**CITY OF WOODLAND PARK  
BOARD OF ADJUSTMENT AGENDA  
August 19, 2019 – 6:30 pm  
Woodland Park Council Chambers  
220 W. South Avenue, Woodland Park, CO**

| <b>SUBMISSION OF CERTIFIED RECORD<br/>         IN THE MATTER OF<br/>         THE APPEAL FROM THE ADMINISTRATIVE ORDER APPROVING<br/>         SPR 19-001 THE VILLAGE AT TAMARAC SITE PLAN (the "ORDER")</b> |  |                                                                    |

| <b>CITY RESPONSE TO PAUL B. NEAL III, DAWN C. NEAL, CAROLE MOLDEN,<br/>BROOKE SMITH AND KAROLYN SMITH APPEAL<br/>IN THE MATTER OF<br/>THE APPEAL FROM THE ADMINISTRATIVE ORDER APPROVING (SPR-19-001)<br/>THE VILLAGE AT TAMARAC SITE PLAN (the “ORDER”)</b> |  |                                     |

ATTACHMENT 'E'

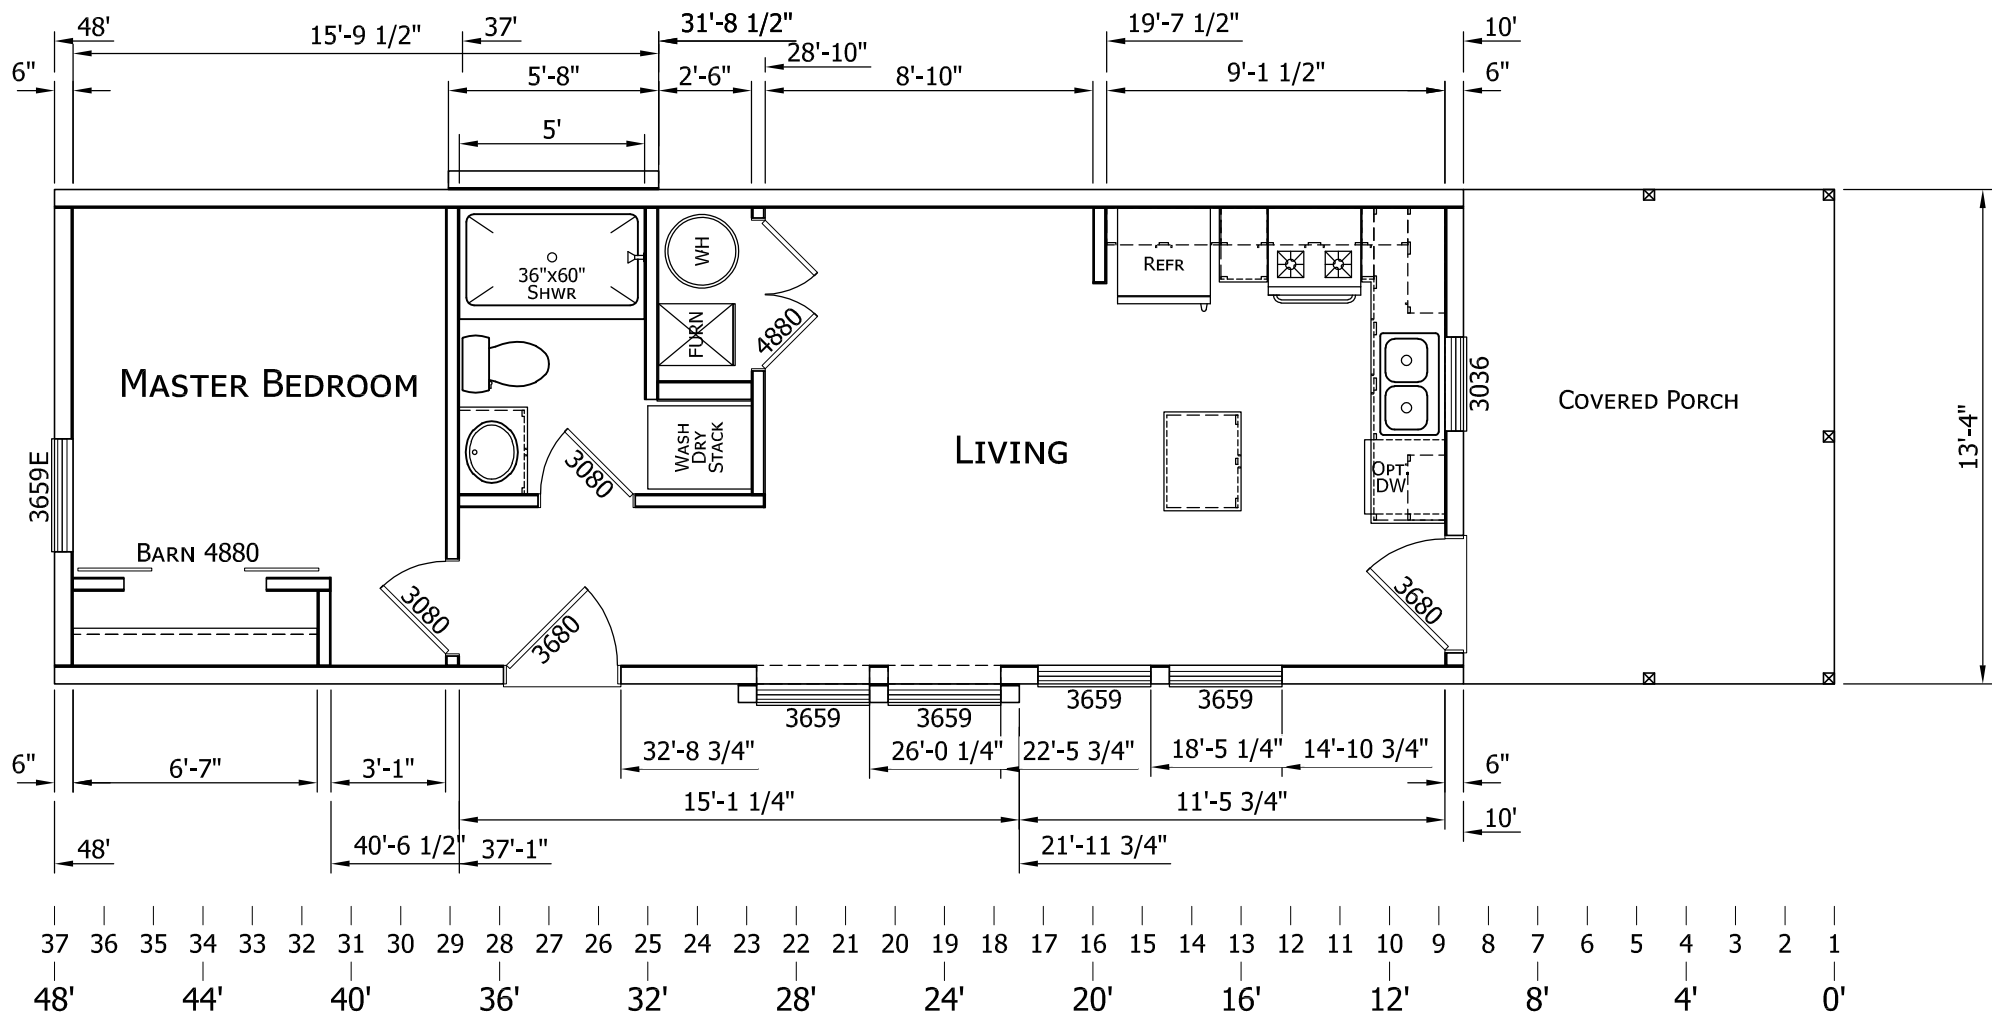
6. The Applicants failed to submit required documents per the initial Site Plan Review Letter (page 5, Architectural Exhibit (AE01), paragraph a.), “Elevations need to show more realistic representation of multiple units with scaled spacing, colors and materials. Specifically, a rendering to scale that depicts at least six units of different colors, design and porch styles shall be submitted.”

These discrepancies can be readily resolved by requiring the Developer to provide the actual floor plans of the units to be built. Architectural Exhibit AE01 only shows photographs of the Champion Home Park Model RV tiny home. That unit is only 399 sq ft. Yes, there is a "storage loft" in some units; however, that loft would not be included in the square footage calculation.

request to supplement Architectural Exhibit (Sheet AEO1). A color rendering of the elevations is not a City Code requirement and it was determined by the Staff that a rendering depicting two units side by side in 4 different color schemes was adequate.

**Complies.** A unified architectural style is provided with reference to building materials and design on Sheet AEO1. Due to Staff's concern about the density and repetitive nature of the building layout, a rendering to scale that depicts at least six units of different colors, design and porch styles is required. **A rendering was provided on July 18, 2019 with four units of different colors and designs.**
